NOTICE OF INTENTION TO DRILL - CORRECTED COPY

Tide Water Associated Oil CompanyMontiethWell No. 1

of Sec. 25, T. 16-S, R. 36-E, N. M., P. M., Levington Field, Lea County.

AREA 640 ACRES

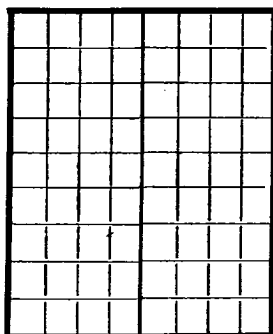
Original Form C-101 for above well listed location as being 330 feet west of east line. Because of RR r/w it was necessary to move location 75 feet west.

Approved _____ JAN 15 1948 19____
except as follows: Cement must return to top of salt section on 5 1/2" Csg.
